**CALIFORNIA COASTAL COMMISSION**

## STAFF REPORT: REGULAR CALENDAR

**Application Number:** 5-12-301

**Project Location:** 283 Trino Way, Pacific Palisades, City of Los Angeles

RETAINING WALLS  
 BASEMENT PLAN  
 SHEET  
**S2.1**

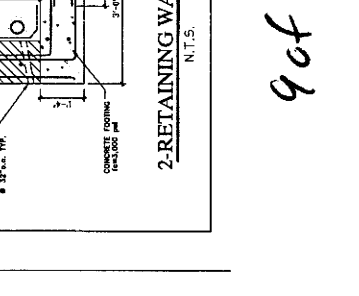
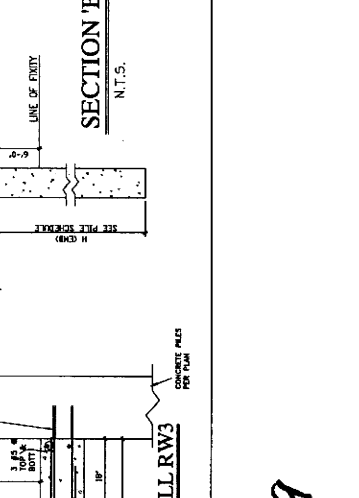
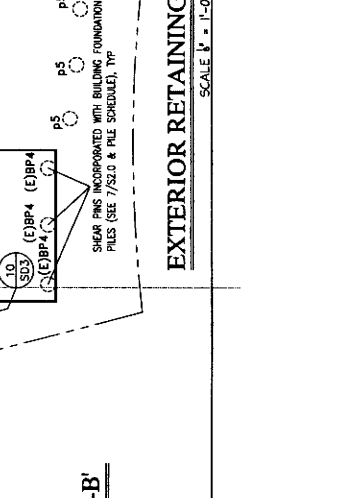
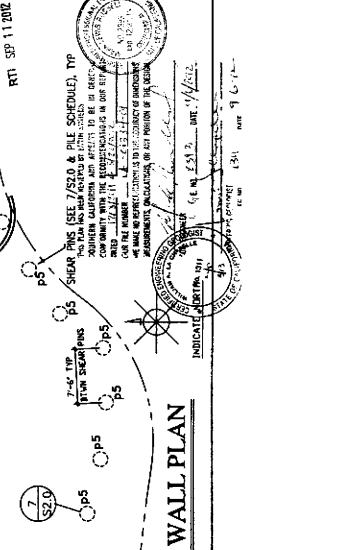
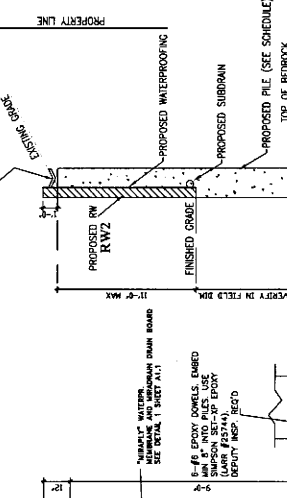
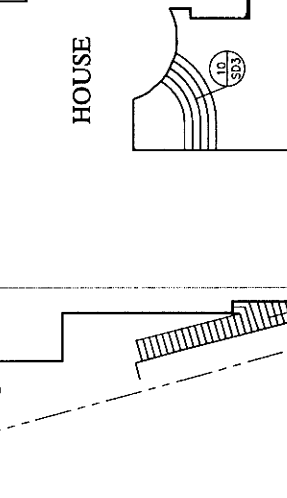
1. The structural engineering plans do not conform with report recommendations (See Sheet S2.1).
2. ESSC cross-section A-A' indicates the Tm1 and Tm2 contact. At the upper portion of the pile supported retaining wall, the contact is 45 feet below the finished pad grade. (See the upper soldier pile location on cross-section A-A'). It is not the 6 feet shown on Sheet S2.1. This is a major discrepancy between the report recommendations and the structural plans.

**EXHIBIT NO. 9**

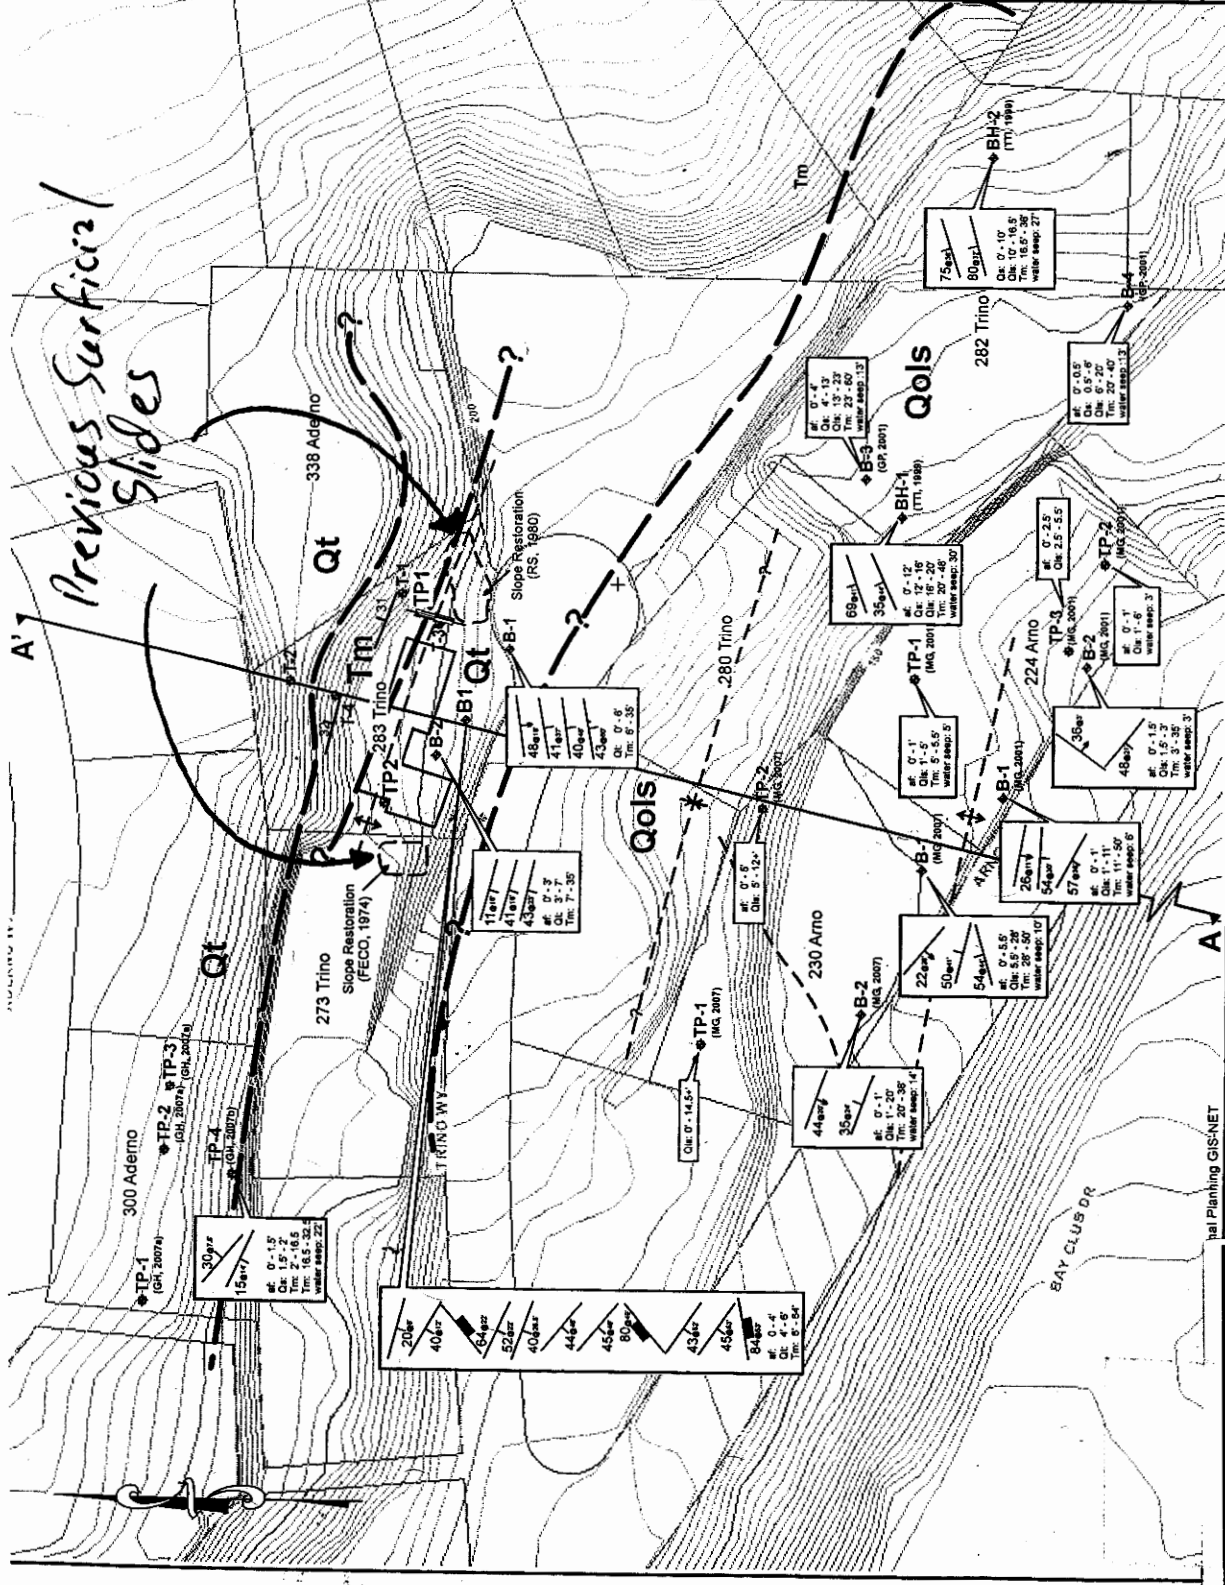
12. Based on the geologic map, many of the proposed soldier piles will penetrate terrace deposits before encountering bedrock. Geologic cross-section A-A' indicates piles will not encounter terrace deposits. Terrace deposits may not be capable of bridging the 10' to 12' distance between the soldier piles until the wall is completed. This condition places the residence at 334 Aderno at risk.

<b>GEOLOGIC CROSS SECTION EXTENDED</b>	
PROPOSED RESIDENTIAL ADDITIONS	
283 TRINO WAY	
PACIFIC PALISADES, CALIFORNIA	
	<b>Earth Systems</b>
Southern California	
12/08/2011	LA-01384-01

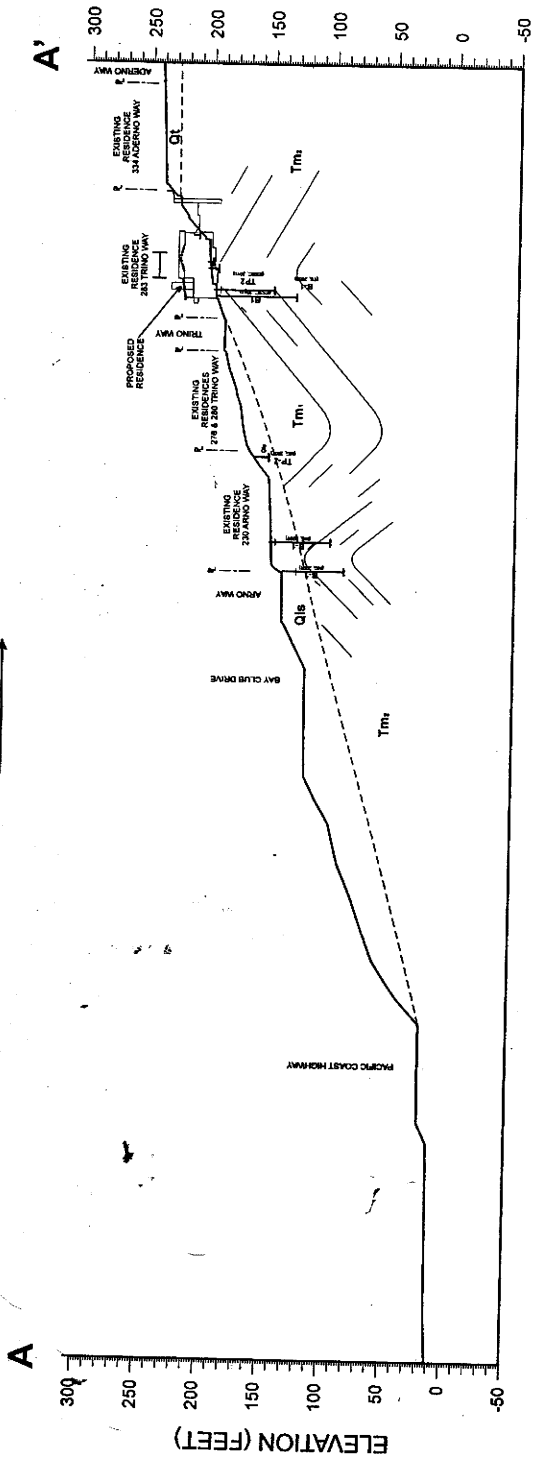
1. Cross-section A-A' does not properly depict the relationship of bedrock and terrace deposits (as compared to the geologic map). The cross-section shows terrace deposits terminating 3 feet south of the northerly property line along a nearly horizontal contact at elevation 229. The geologic map shows terrace deposits 24 feet south of the property line and at an elevation of 220.

11. Cross-section A-A' does not properly depict the relationship of bedrock and terrace deposits (as compared to the geologic map). The cross-section shows terrace deposits terminating 3 feet south of the northerly property line along a nearly horizontal contact at elevation 229. The geologic map shows terrace deposits 24 feet south of the property line and at an elevation of 220.
12. Based on the geologic map, many of the proposed soldier piles will penetrate terrace deposits before encountering bedrock. The geologic cross-section A-A' indicates piles will not encounter
